Proposed Amendment No. 8

Building Height & Density Review,

Cherrywood Planning Scheme 2014

May 2021

Proposed Amended Map 2.3 Building Heights

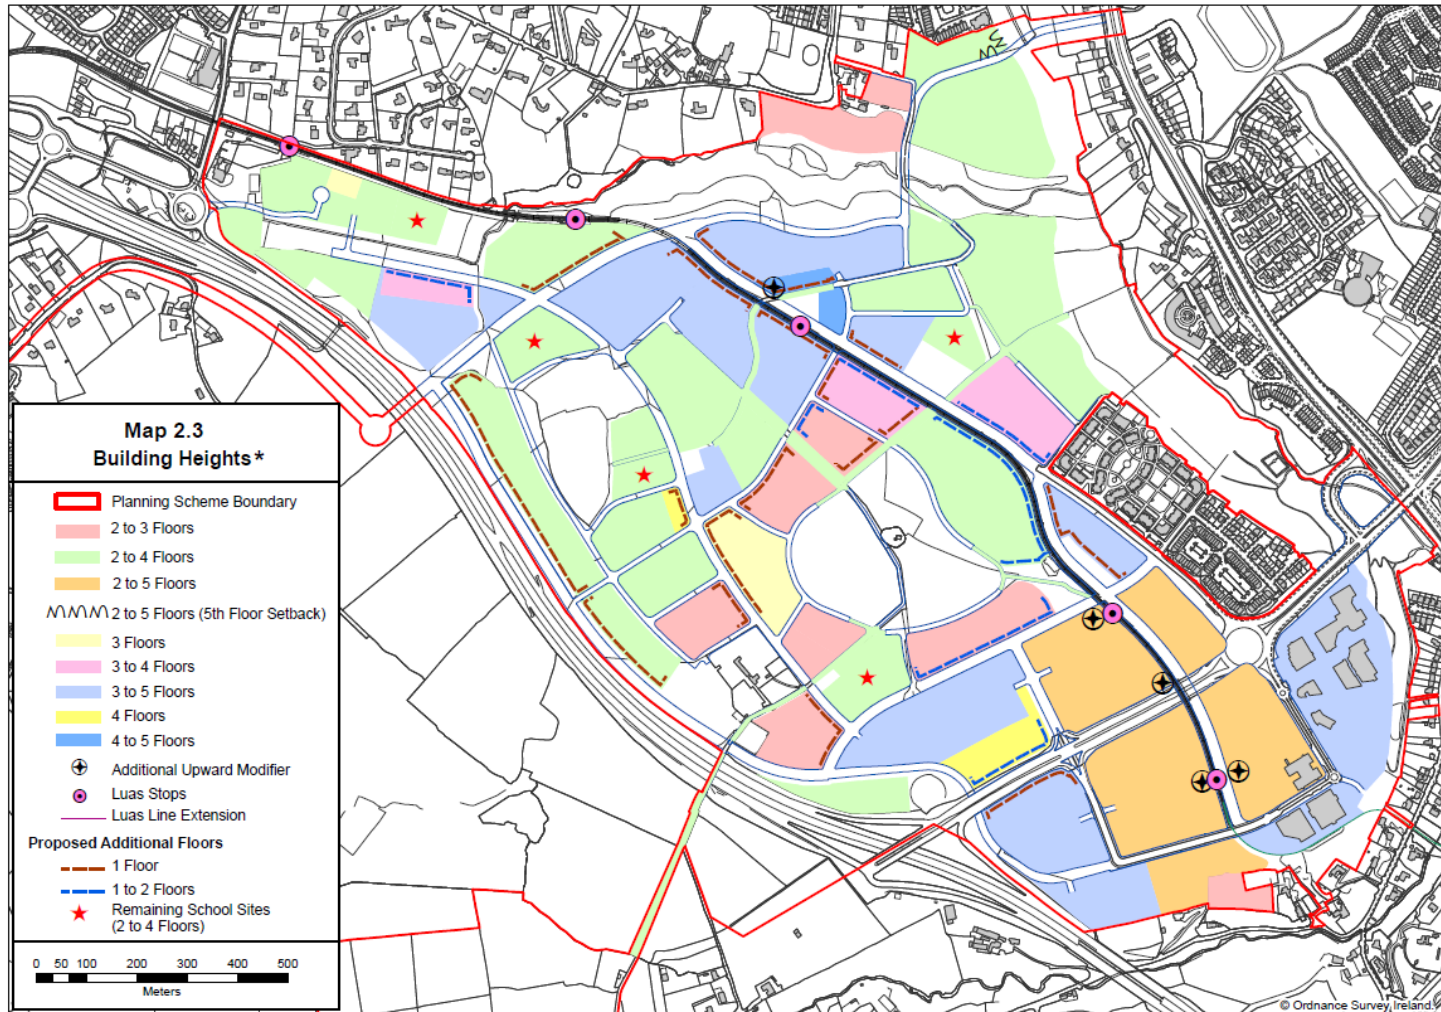
It is an objective of the Planning Scheme (Specific Objective PD21) to ensure that Cherrywood is developed in accordance with height limits as set out in Map 2.3 Building Height subject to the building making a positive contribution to the built form, to the criteria in Section 2.9.1 and the Specific Objectives in the Planning Scheme.

PD 21 To allow building height within the range of storeys identified and set out on Map 2.3 subject to Section 2.9.1 Criteria for Assessing Building Height in the Planning Scheme. These heights have been informed by the characteristics of each site and are the maximum permissible on each development plot.

Appendix H: Indicative Street Sections showing Proposed Maximum Building Heights.

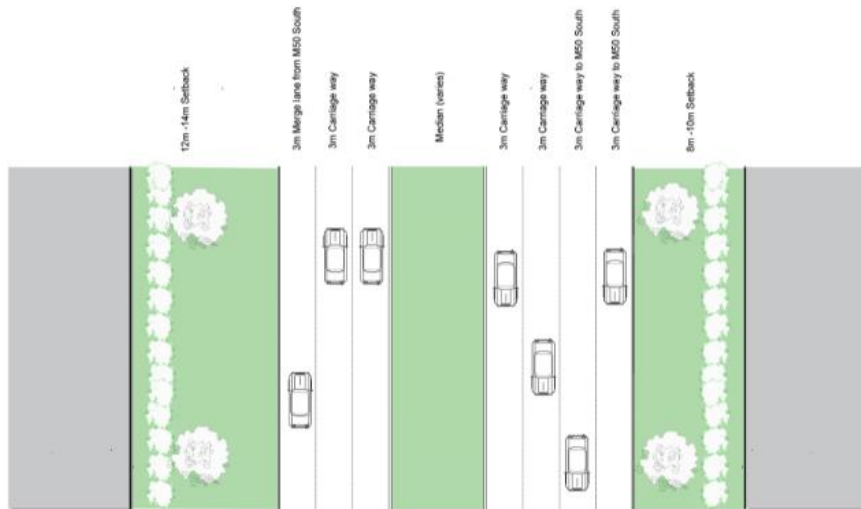
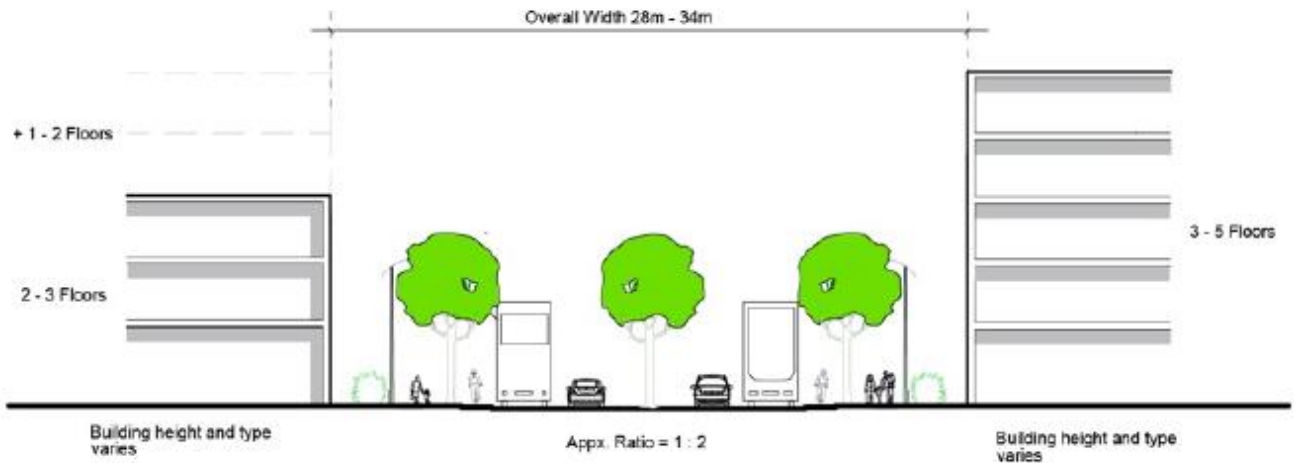
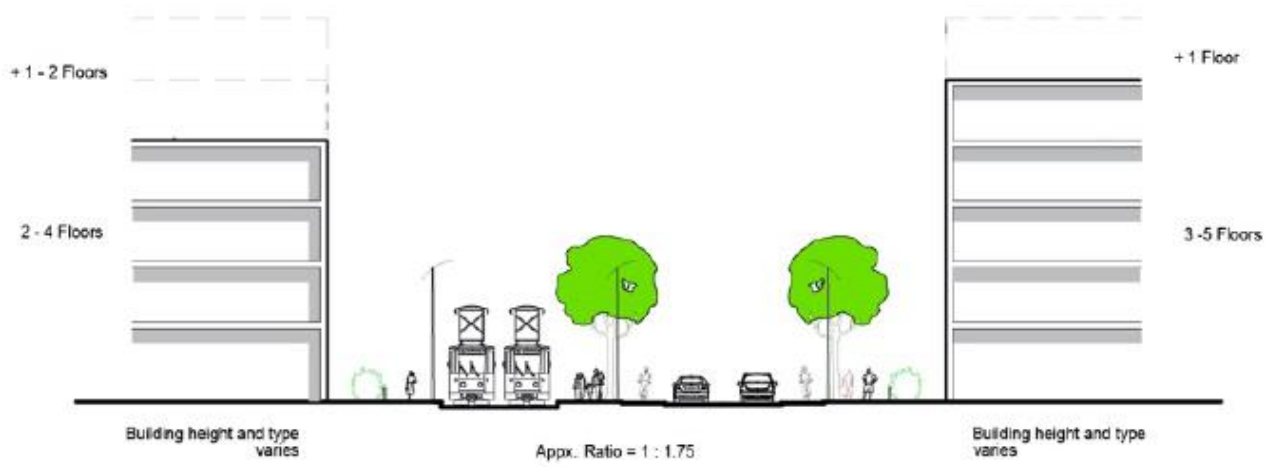
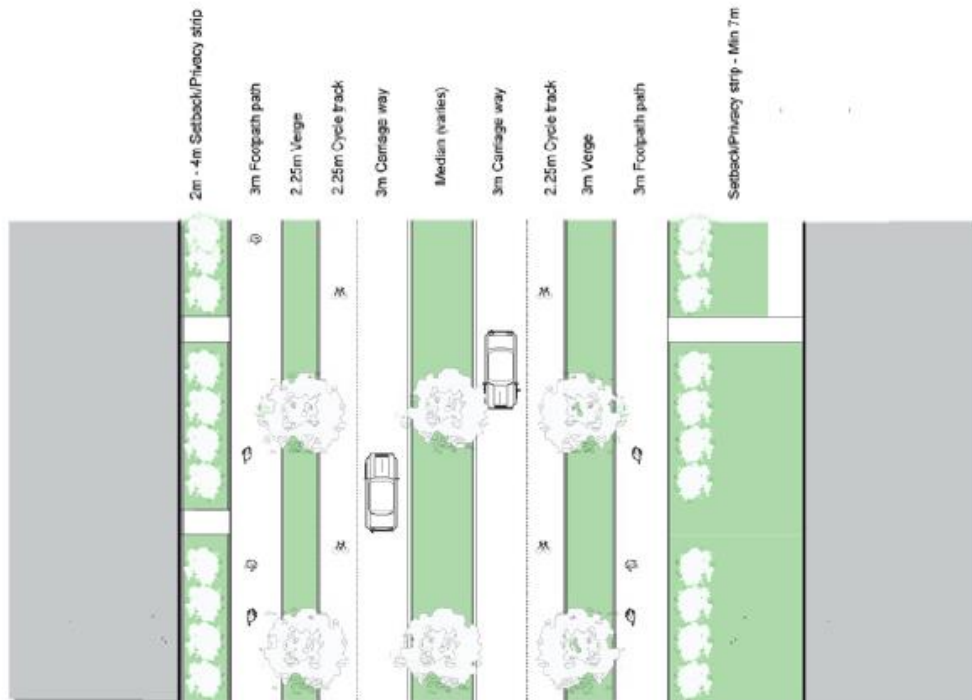
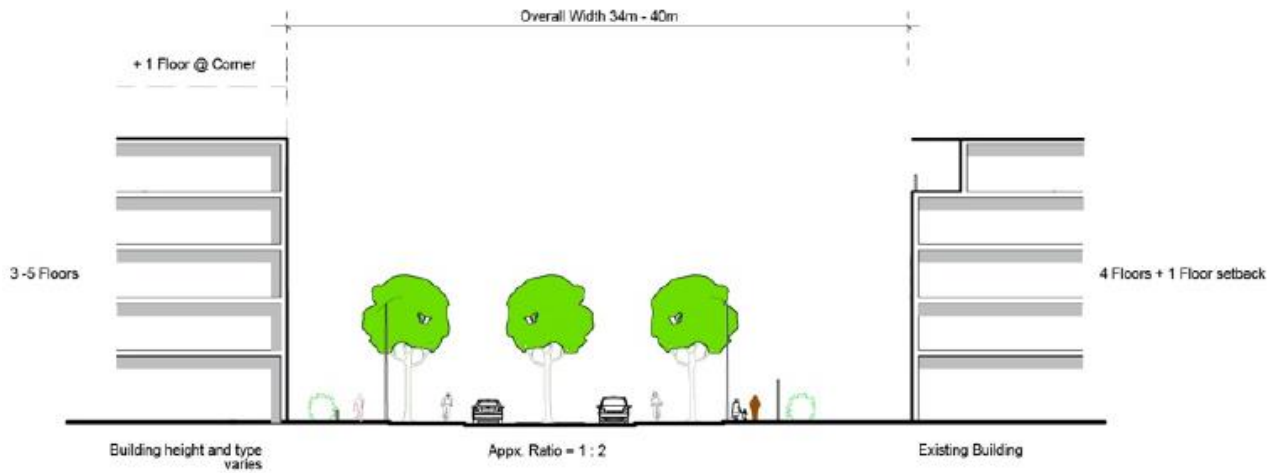
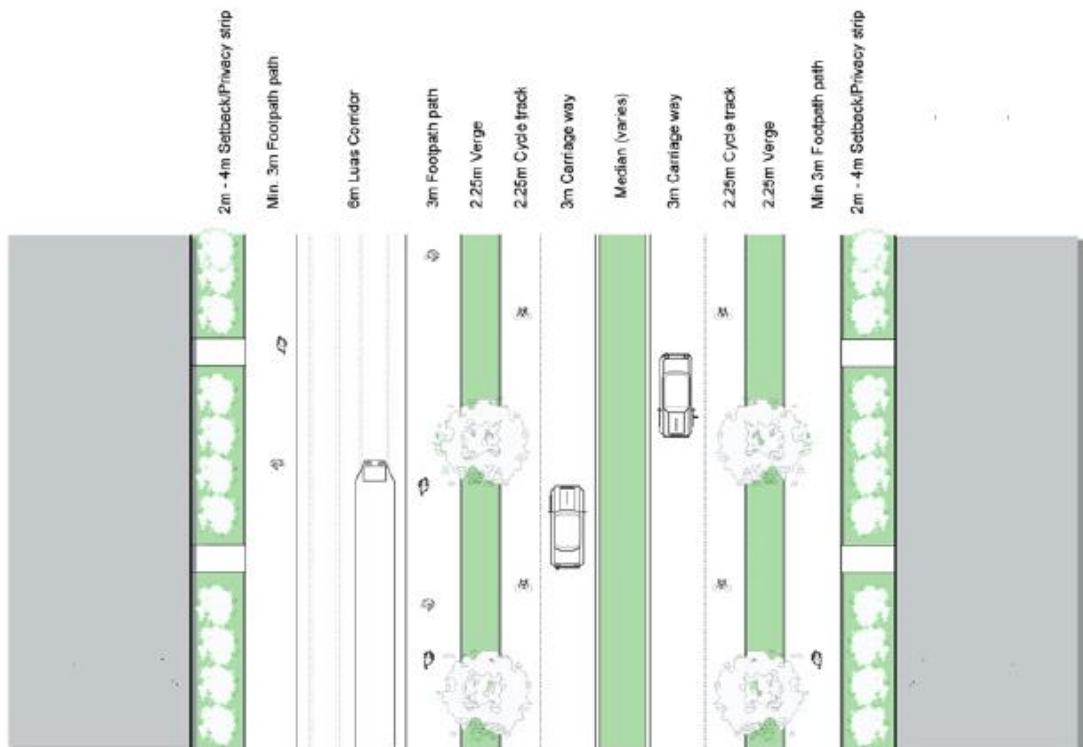
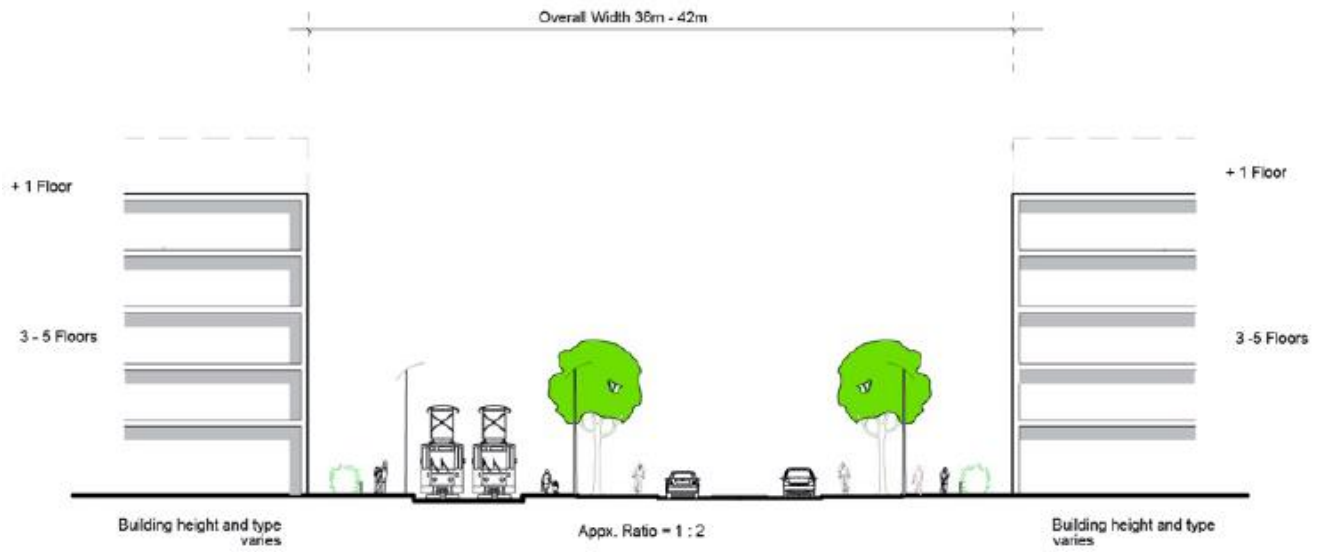
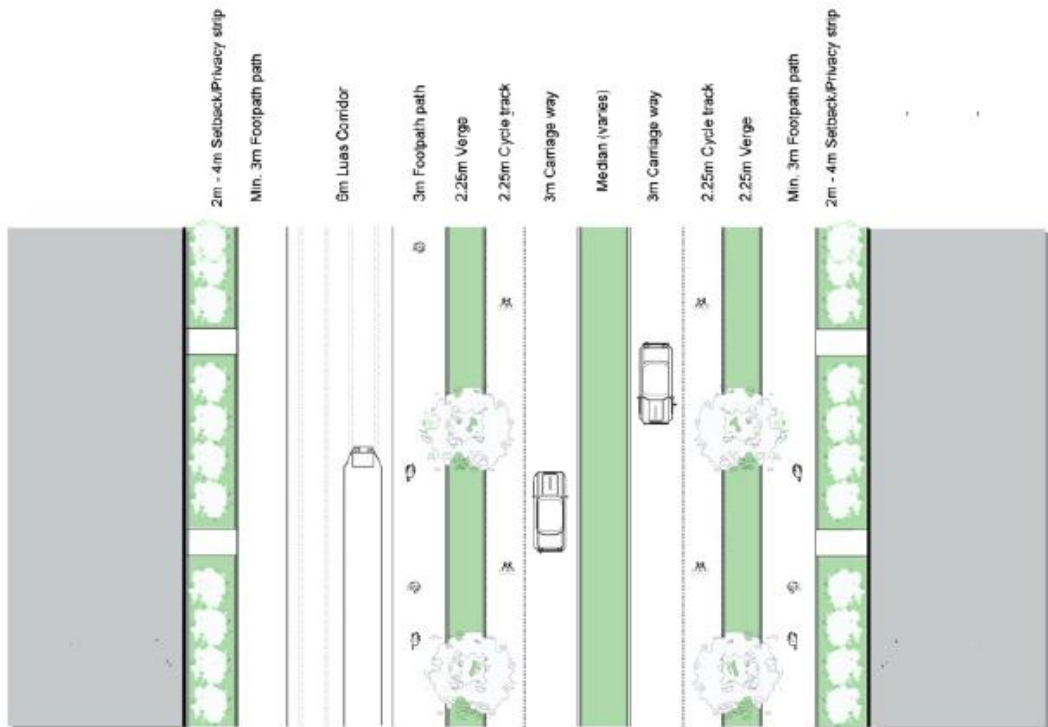
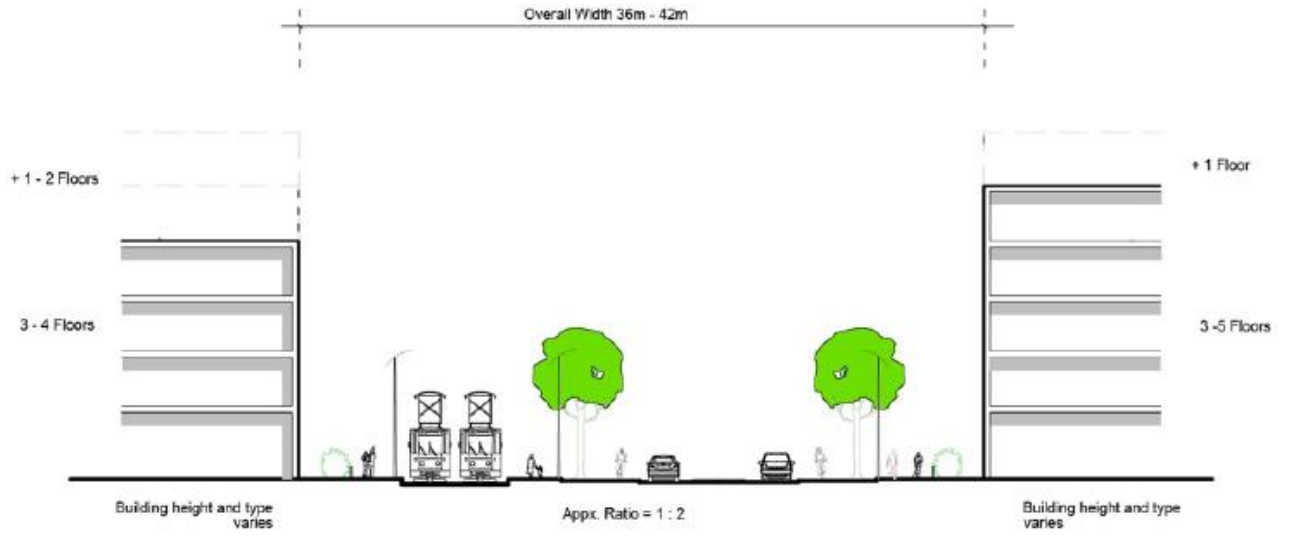
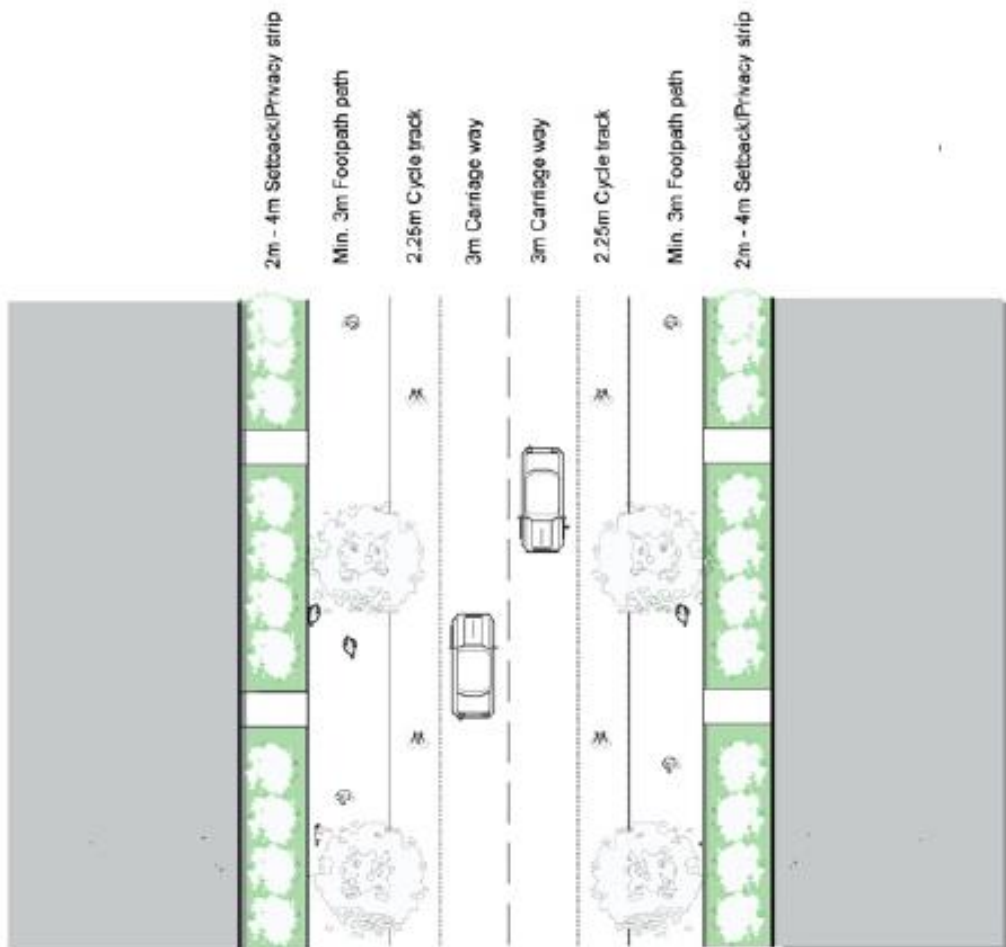
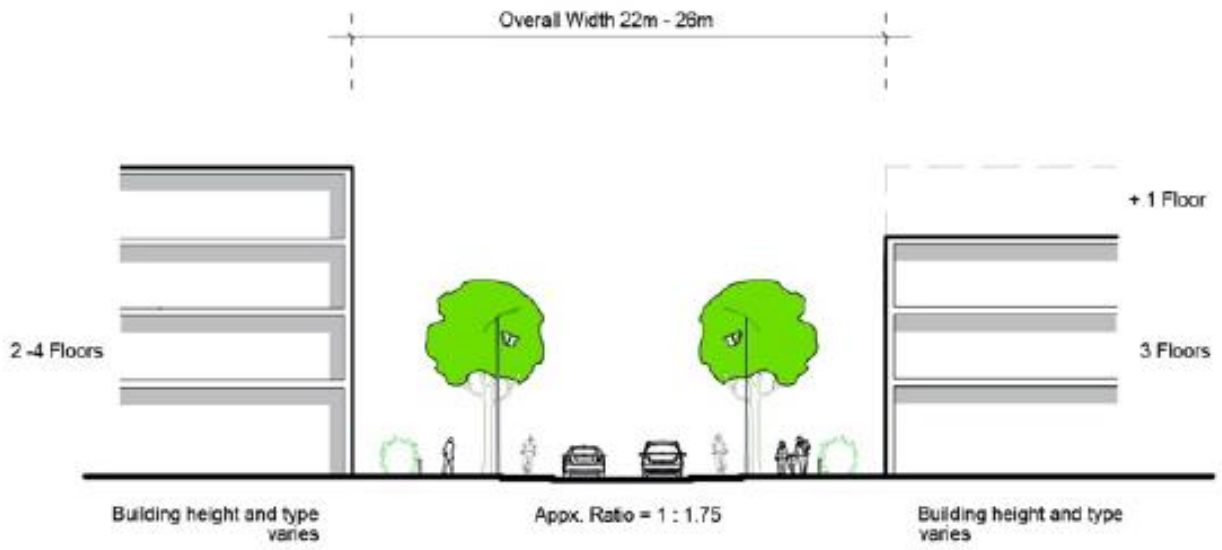
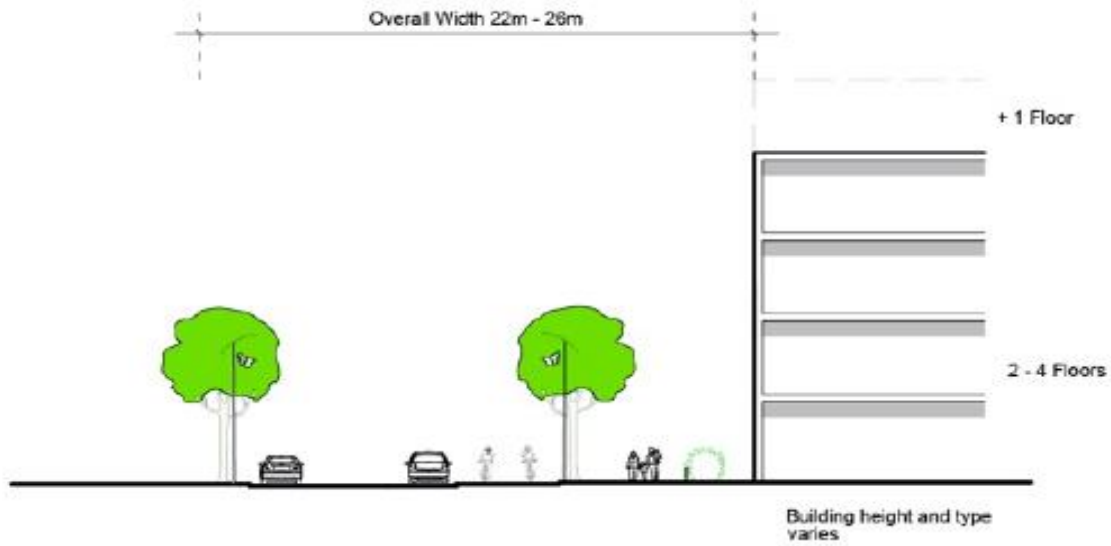
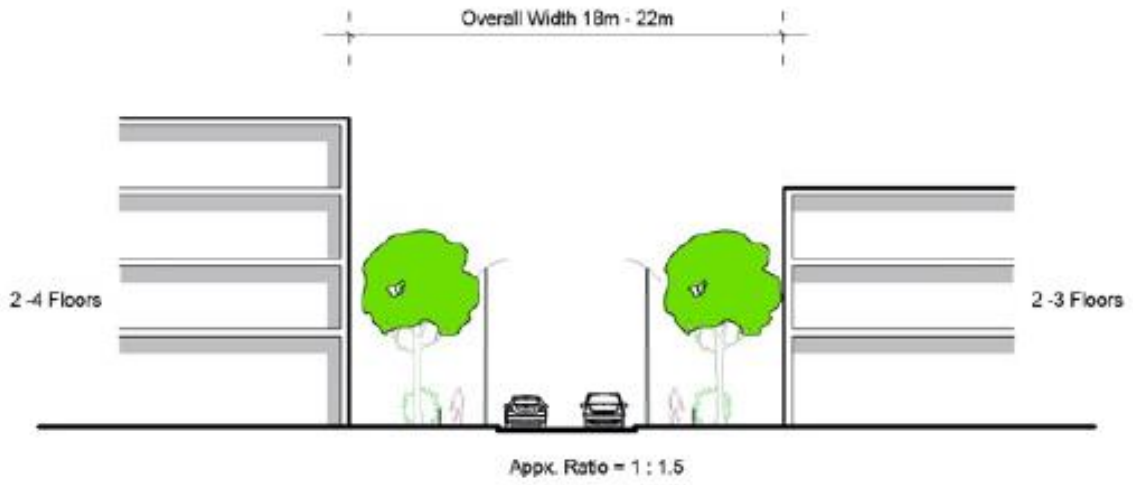
Insert New Appendix H at the end of the Cherrywood Planning Scheme Document.
